PIC16F62X Silicon/Data Sheet Errata

The PIC16F62X (Rev. A) parts you have received conform functionally to the Device Data Sheet (DS40300B), except for the anomalies described below.

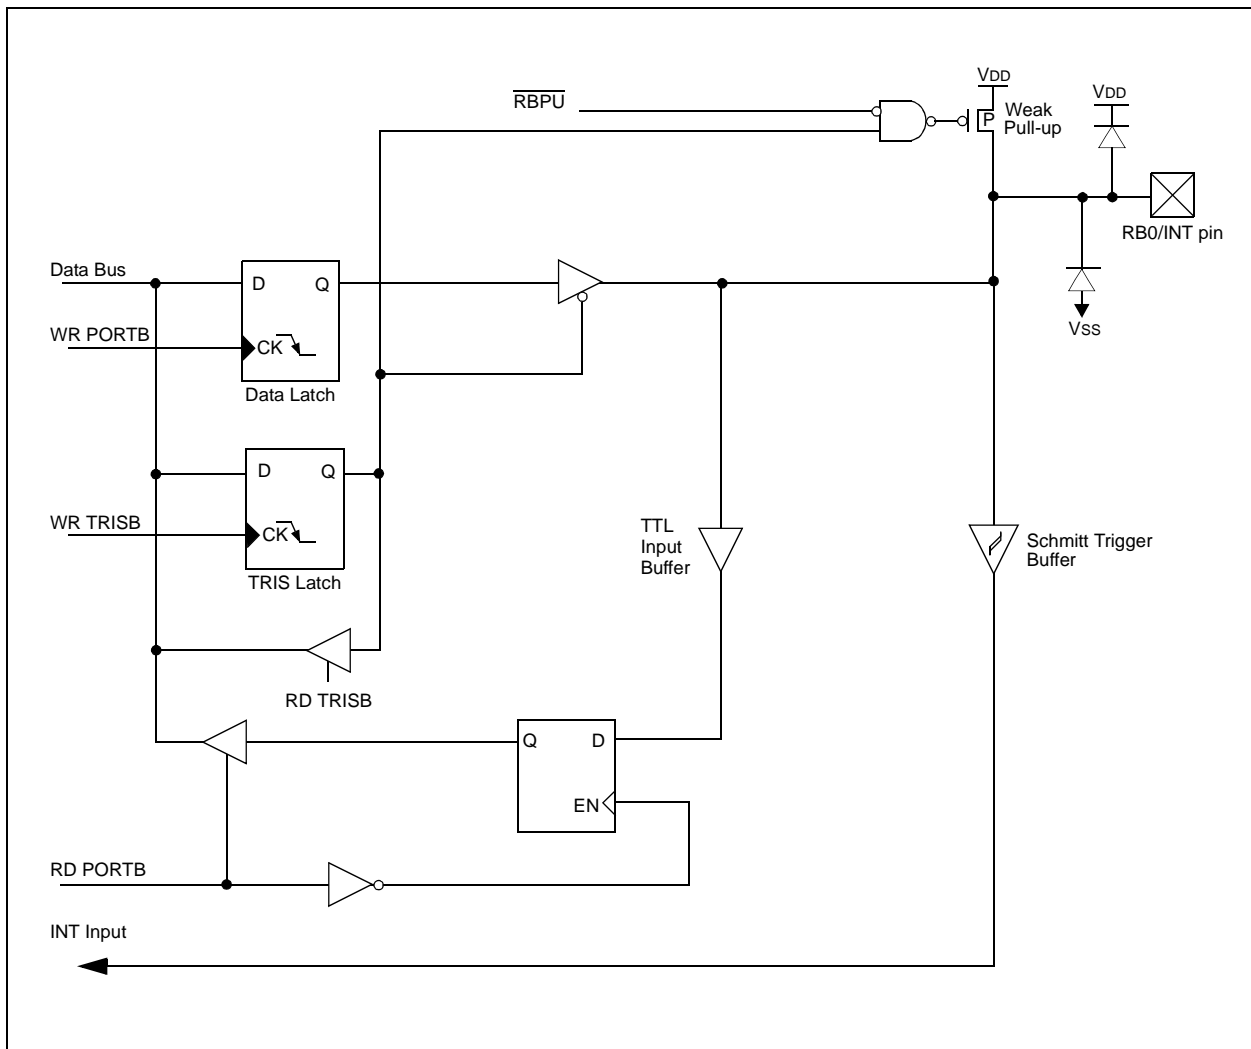
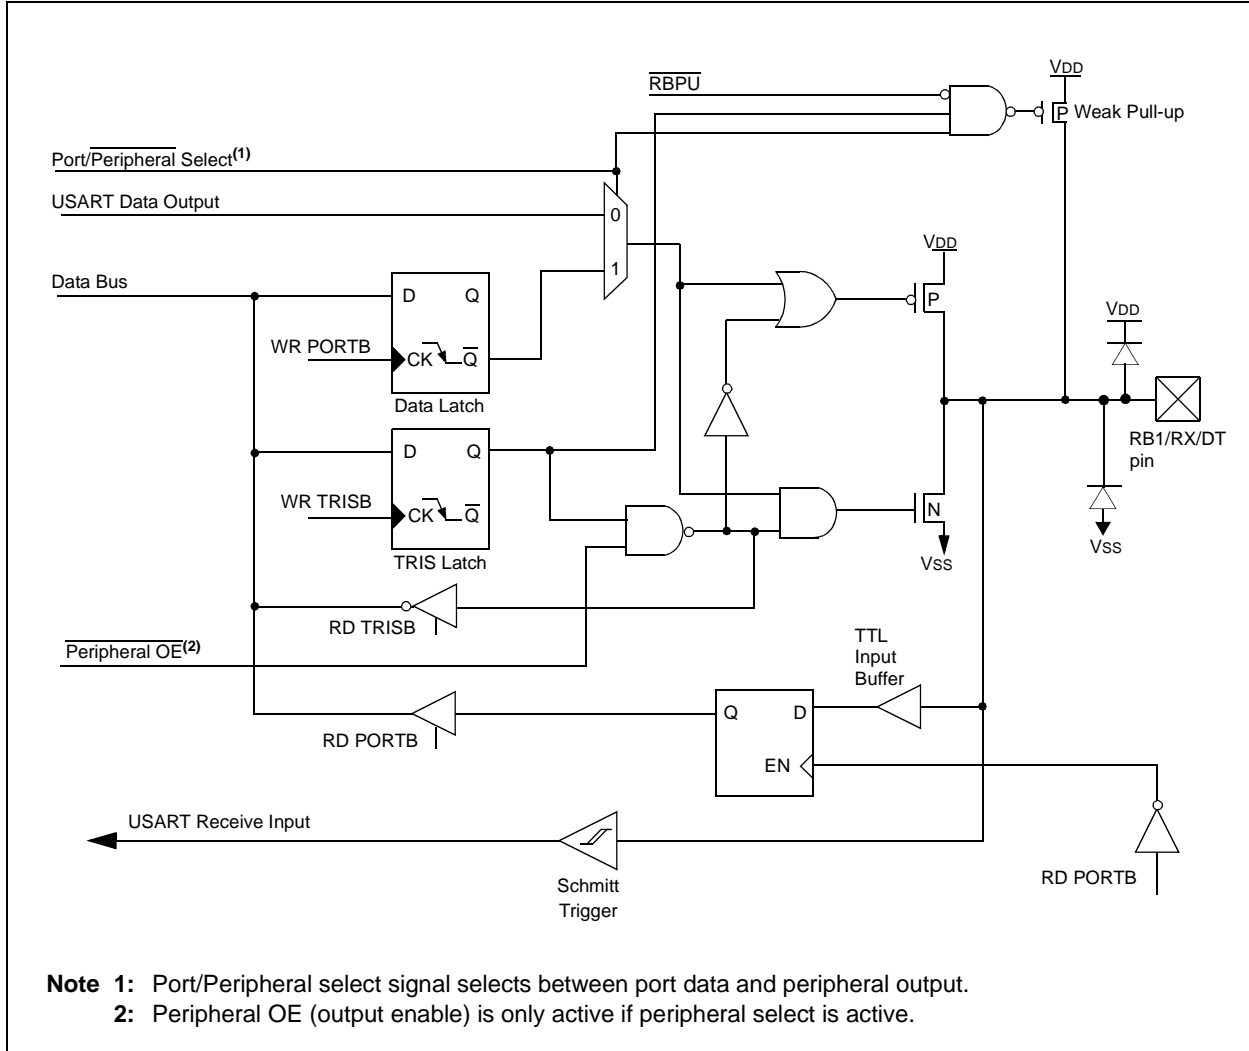
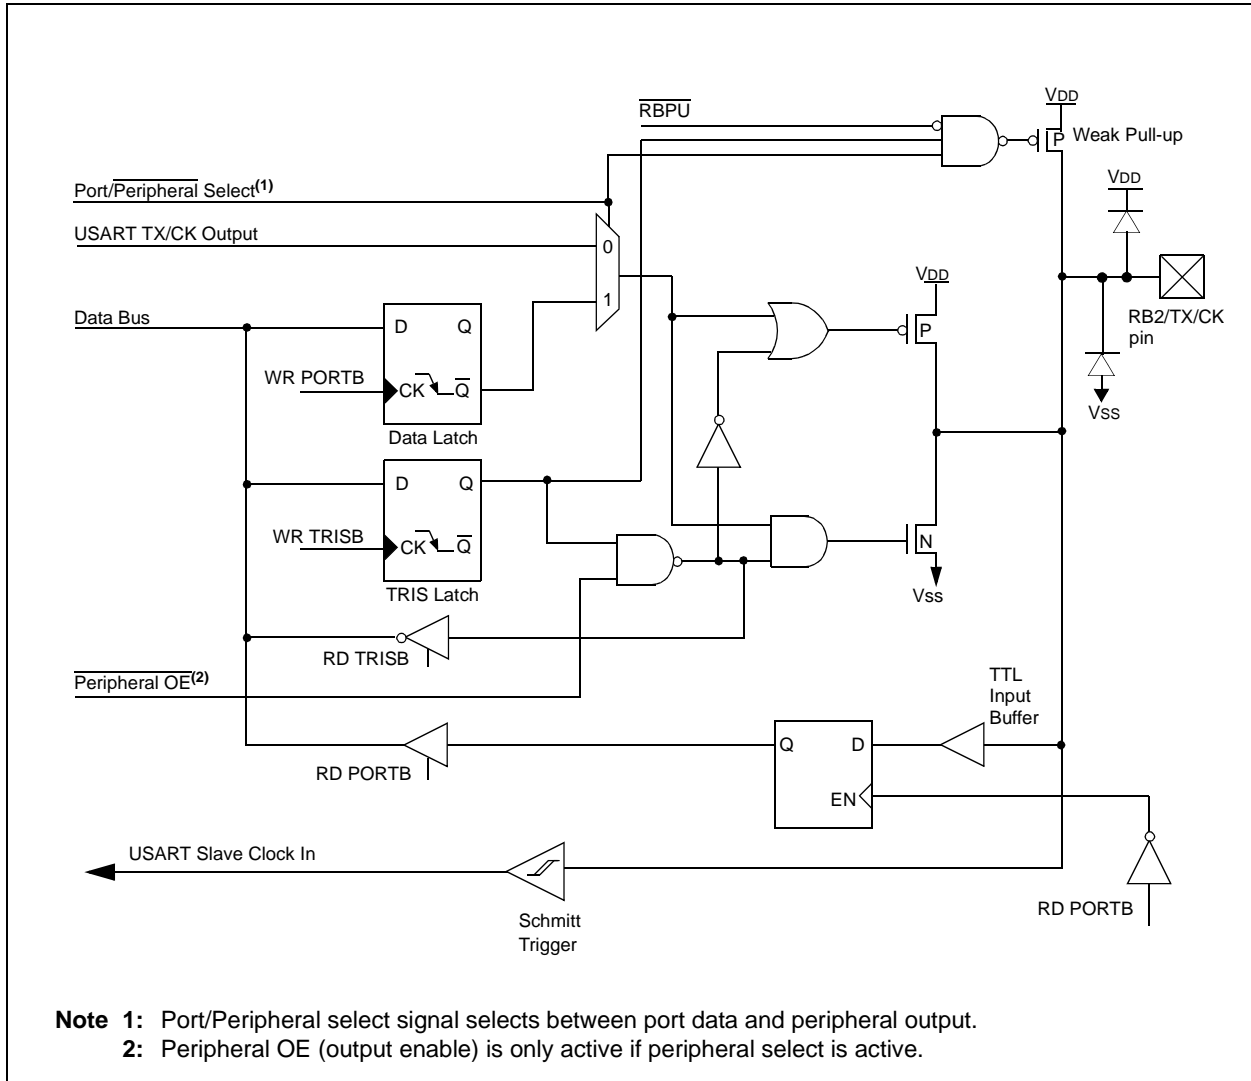
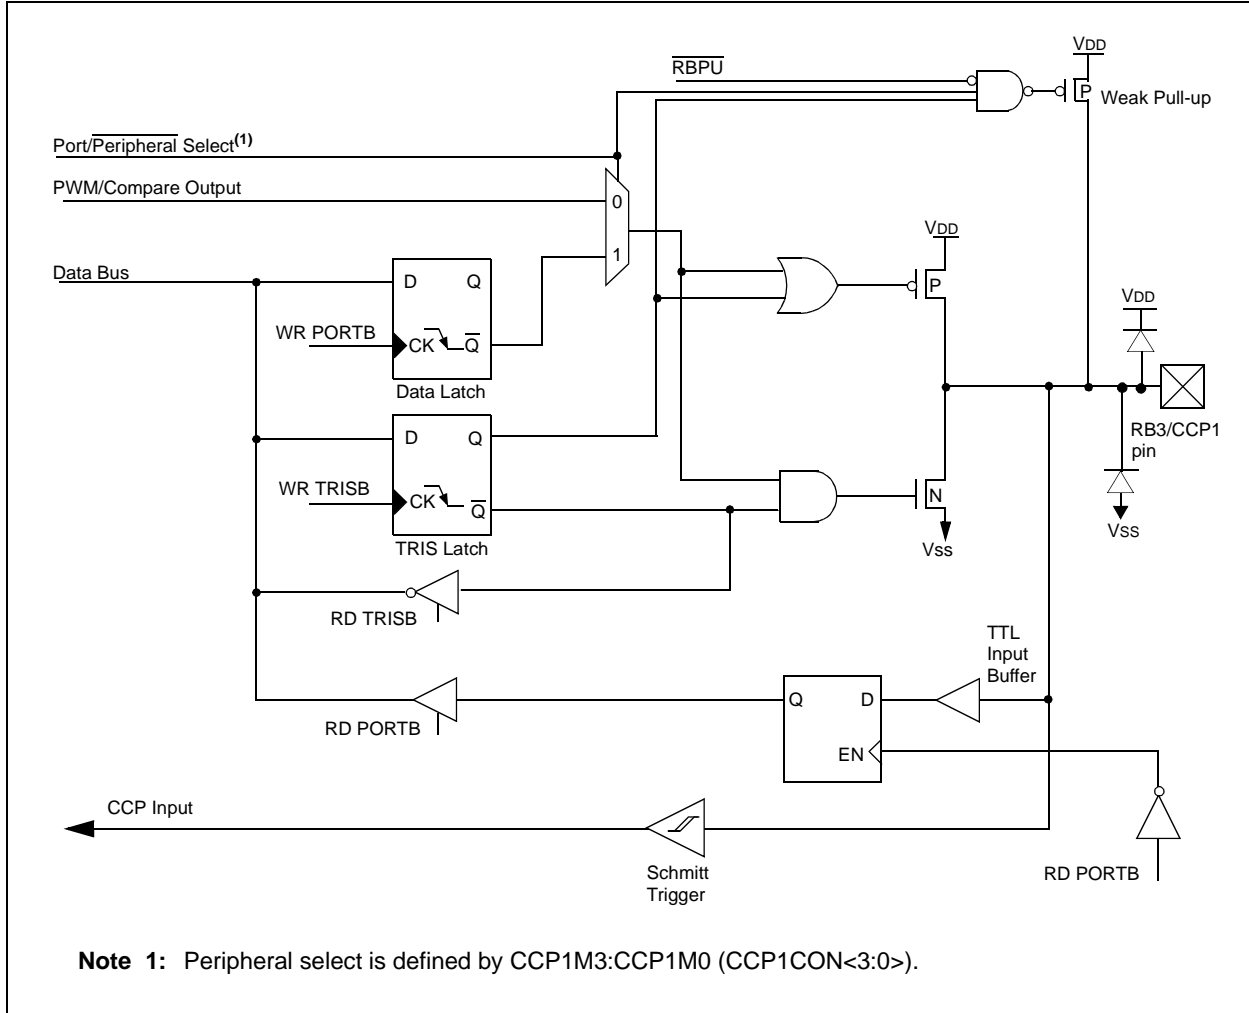
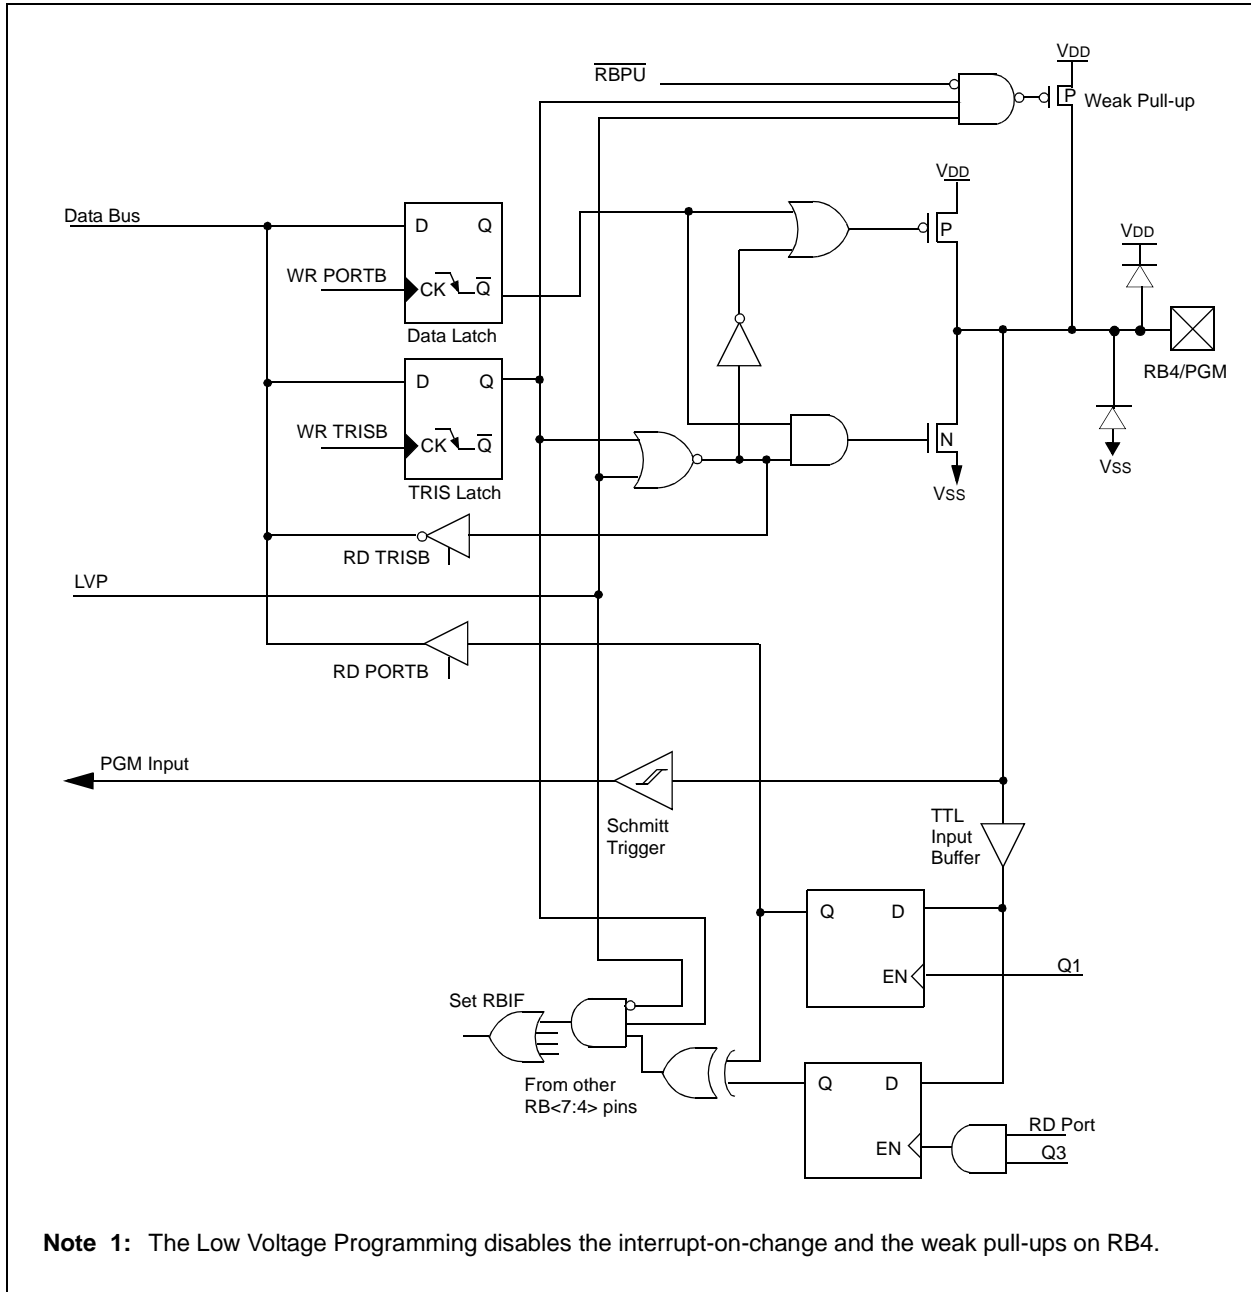
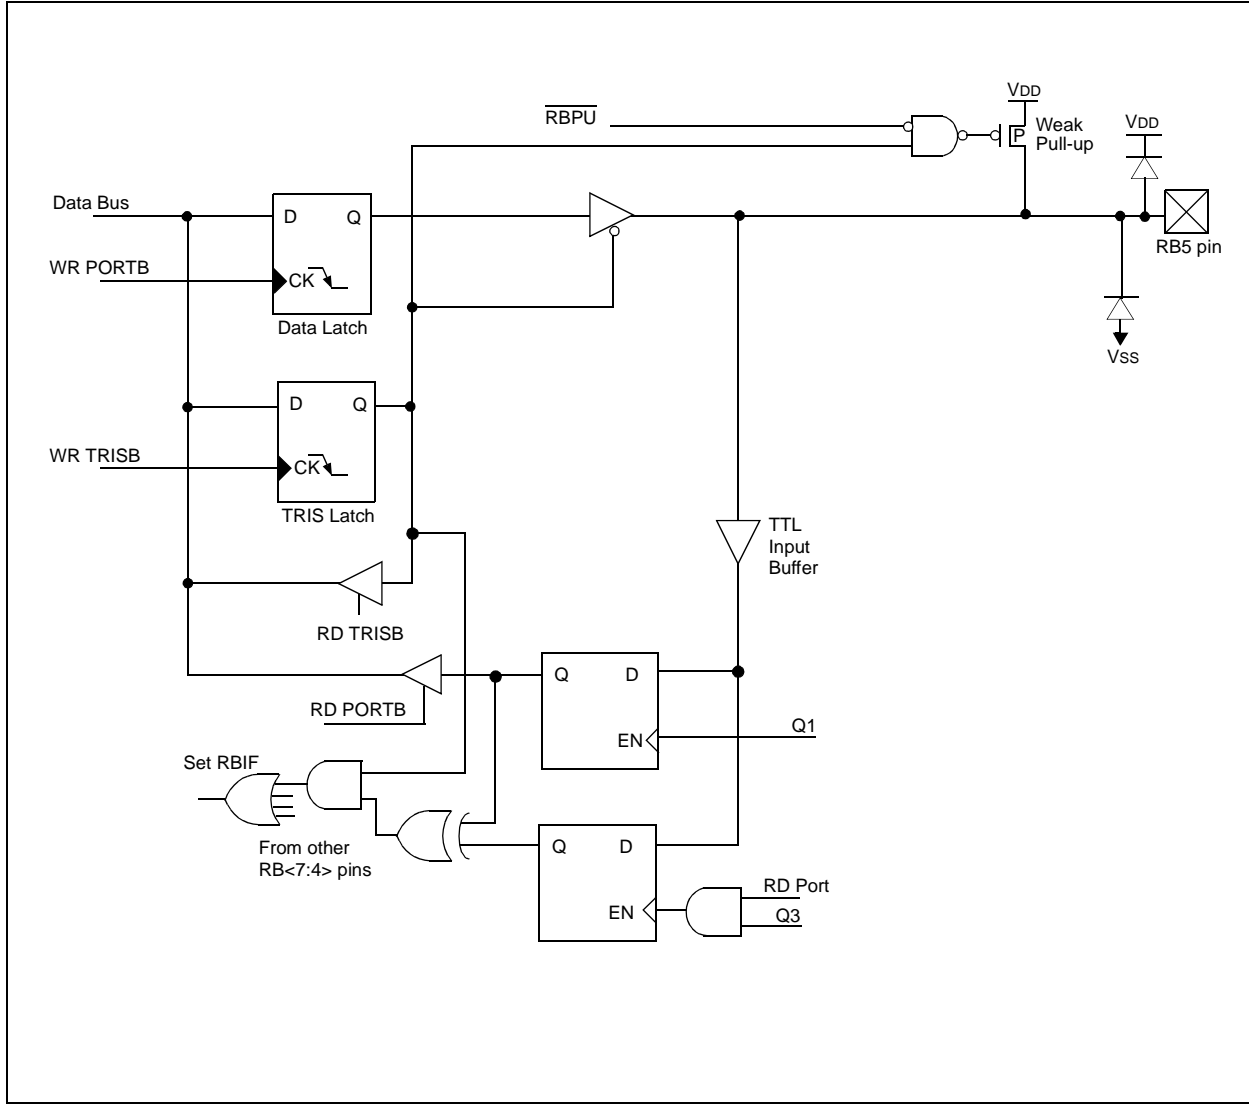
1. Module: I/O Ports

A read of the PORTB Data Direction Register (TRISB) returns the Data Direction state on the port pins themselves and not the contents of the TRISB register latch.
